AS/04 NOTES:
CEILING & BULKHEADS REVISED WITH AS/04 REVISIONS NOT CLOUDED

SQ ALEXANDRA PARK - BLOCK 11
38 CAMERON ST., TORONTO, ONTARIO M5T 2H2

Teepie Architects
LEVEL 13 PLAN

1 LEVEL 13 PLAN
1/A227 1:50

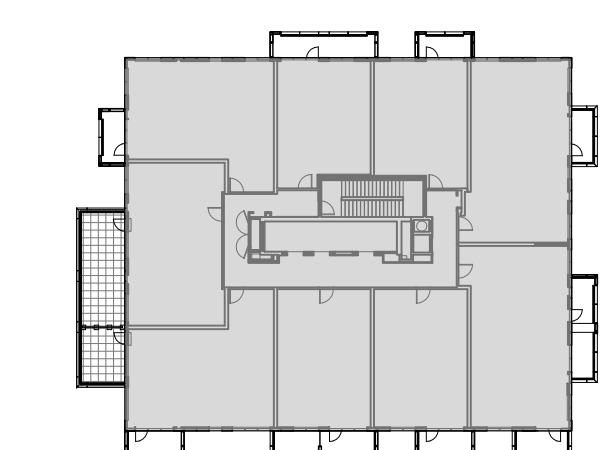
SUITES 1306 AND 1308
ACOUSTIC CEILING C3 AT +2750 THROUGHOUT SUITE. ROUTE RWL ABOVE CEILING. DUCTS AND SPRINKLERS IN TYP. BULKHEADS AT +2450 BELOW ACOUSTIC CEILING.
